UNITED STATES PATENT AND TRADEMARK OFFICE

APPLICATION NO.	FILING DATE	FIRST NAMED INVENTOR	ATTORNEY DOCKET NO.	CONFIRMATION NO.
09/839,001	04/20/2001	Harald Apfelthaler	KWO-17702/01	2739

Office Action Summary

DETAILED ACTION

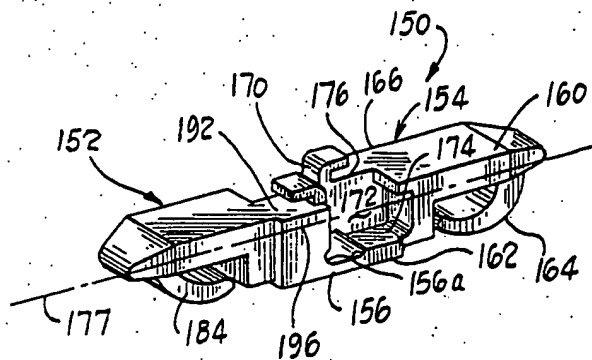
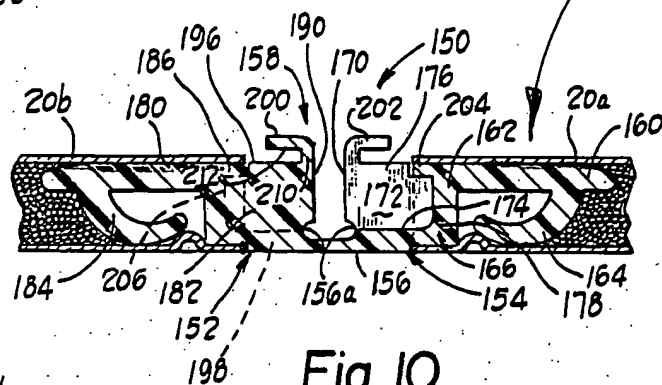
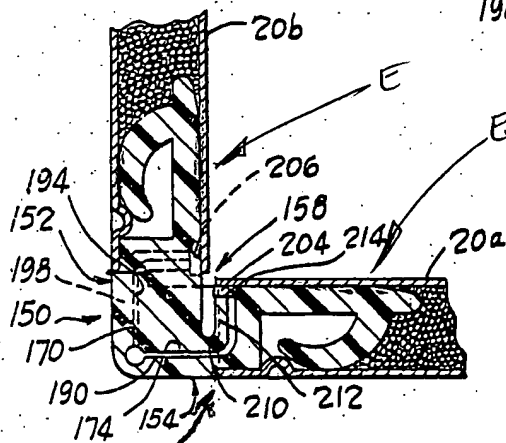
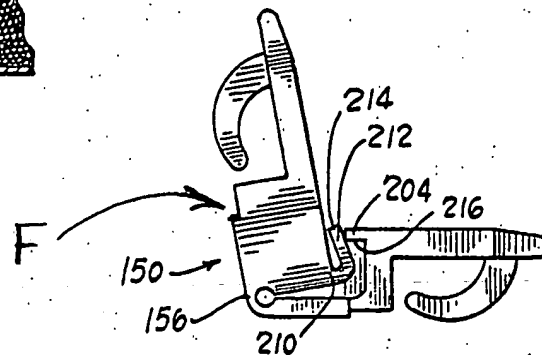
Claim 20 is rejected under 35 U.S.C. 102(b) as being anticipated by US Patent #4,628,582 LEOPOLD. LEOPOLD discloses a muntin (20a,b) having an end (E), an outer surface (colored red), and an inner wall (colored blue) defining a hollow space (colored yellow) having a planar wall (also colored blue) in combination with a terminal plug (150) including a body (152,154), a flange (F and colored purple), a plurality of spring elements (164,184), and a longitudinal slot (156a and colored orange) wherein, when the body (152,254) is inserted into the hollow space (colored yellow) of the muntin (20a,b) the longitudinal slot (156a and colored orange) spreads apart (see figure 10) and the spring elements (164,184) engage the inner wall planar surface (colored blue).
SEE THE MARKED ATTACHMENT

Claims 21 and 22 are rejected under 35 U.S.C. 103(a) as being unpatentable over US Patent #4,628,582 to LEOPOLD. LEOPOLD discloses a muntin (20a,b) having an end (E), an outer surface (colored red), and an inner wall (colored blue) defining a hollow space (colored yellow) having a planar wall (also colored blue) in combination with a terminal plug (150) including a body (152,154), a flange (F and colored purple), a plurality of spring elements (164,184), and a longitudinal slot (156a and colored orange) wherein, when the body (152,254) is inserted into the hollow space (colored yellow) of the muntin (20a,b) the longitudinal slot (156a and colored orange) spreads apart (see figure 10), the spring elements (164,184) engage the inner wall planar surface (colored blue), and the flange engages the outer surface (colored red) of the muntin (20a,b), see figure 11. LEOPOLD discloses the basic claimed muntin and terminal plug combination except for explicitly detailing the width dimensions of the plug body with respect to the hollow space. Although LEOPOLD is silent with regards to the details of the width dimensions of the plug body, he does however detail in column 3, lines 50-53, and column 4, lines 57-59, that the terminal plug member is resiliently deflectable and moves into latching engagement in order to secure with the frame segments. Also, the figures clearly show a very close and snug fit between the terminal plug (150) and the muntin members (20a,b). Hence, it would have been obvious to one having ordinary skill in the art at the time the invention was made that the width of the terminal plug

body of LEOPOLD is greater than the width of the hollow space in order to facilitate deflection of the spring elements (164,184) and the close fit of the terminal plug (150) within the hollow space (colored yellow) of the muntins (20a,b) as shown in the figures. Further, due to the fact that the terminal plug of LEOPOLD also functions to prevent loss of a desiccant material disposed within the muntin members, it is evident that a snug "friction" fit is formed between the terminal plug and the hollow space defined in the muntin. In reference to claim 22, the plug body (152,154) comprises opposing walls (colored orange) that define the longitudinal slot. SEE THE MARKED ATTACHMENT.
